DISCUSSION

Proposal

Development Variance Permit Application
517 Marine Drive
March 15th, 2021

Figure 2: Applicant's proposal

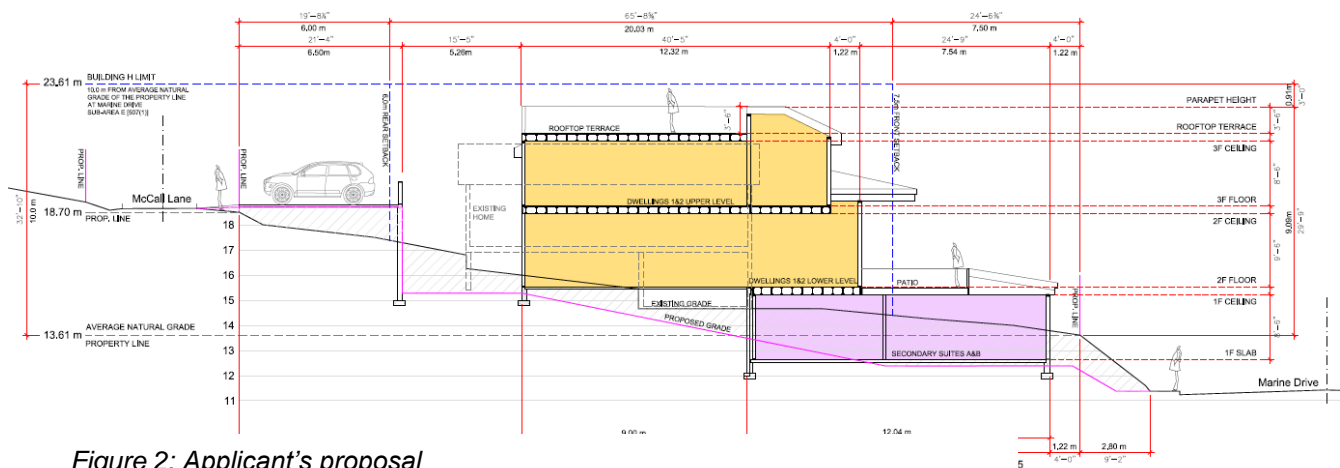
The applicant is proposing to tear down the existing single-family dwelling and build a new duplex with a secondary suite in each unit. Figure 2 below shows a cross section of the proposed duplex. The secondary suites are proposed to be accessed from Marine Drive (shown in purple), with the duplex units accessed from McCall Lane (shown in yellow). The applicant's proposal summary is enclosed as Attachment A.

Figure 3: Applicant's proposal in relation to the homes uphill

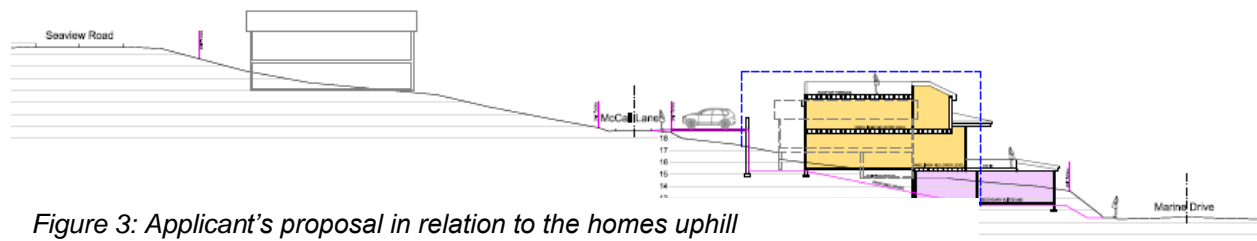
Figure 3 shows the proposal in relation to the uphill properties. The applicants are conforming to the maximum 10 m height from Marine Drive and therefore the homes across McCall Lane will maintain views over the proposed duplex. Neighbour notifications will solicit comments from neighbours.
